## 18C Operator Interface Equipment Characterization

The information in this appendix of the reference ABWR DCD, including all subsections and figures, is incorporated by reference with the following departures and a supplement.

STD DEP T1 3.4-1 (Figure 18C-8)

Figure 18C-8 Overall Configuration of Operator Interface System

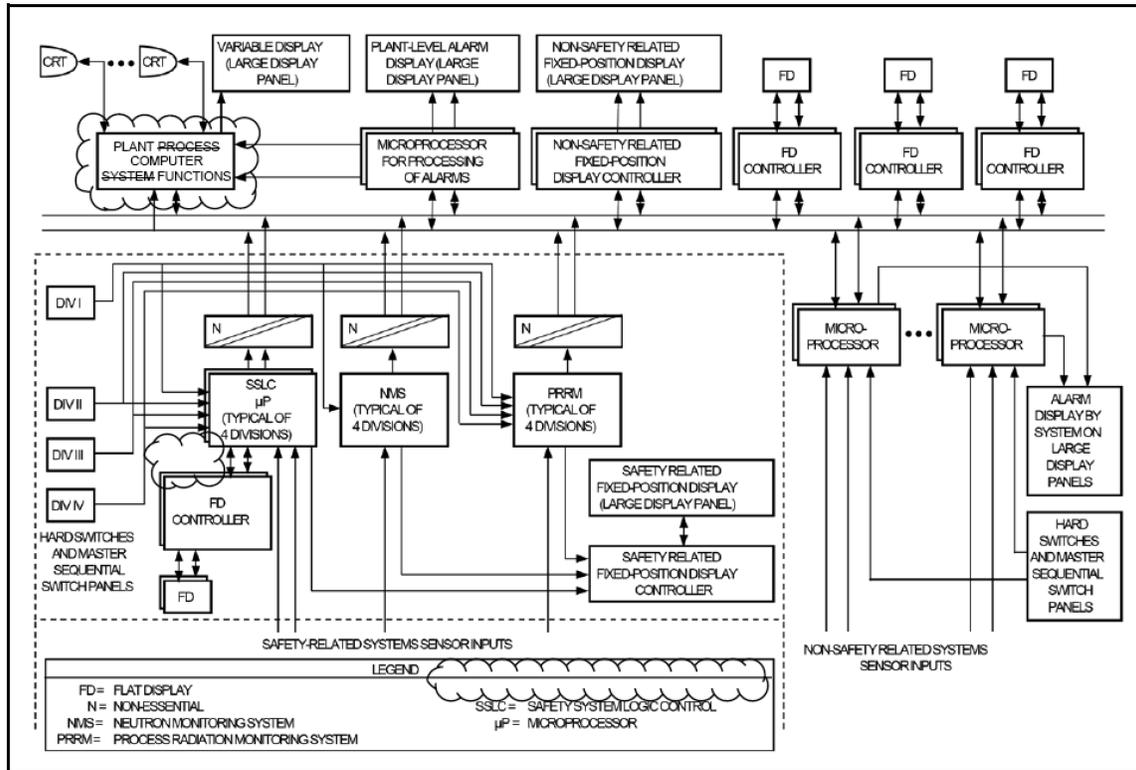
*A characterization of the plant instrumentation and control systems architecture which supports the control room operator interface is illustrated in Figure 18C-8. As shown in Figure 18C-8, display and control capability for both safety-related and non-safety-related systems are driven by microprocessors which are independent of the redundant plant process computer functions. This assures the ability to safely shut down the plant in the unlikely event of computer failure. In the case of the safety-related systems, the microprocessors are divisionally dedicated and are each electrically isolated from the rest of the system.*

The instrumentation and control systems architecture is not identical to the conceptual design described in Appendix 18C. The changes in the next paragraph reflect the architecture and configuration.

~~The plant wide, fiber optic Essential Multiplexing System (EMUX) provides the communications network for the system. This multiplexing system is actually a series of data acquisition and control networks, separate networks being provided for safety related and non safety related plant systems.~~ The data communication function includes both safety-related and non-safety-related communication performed by separate networks as described in Section 7.9S.
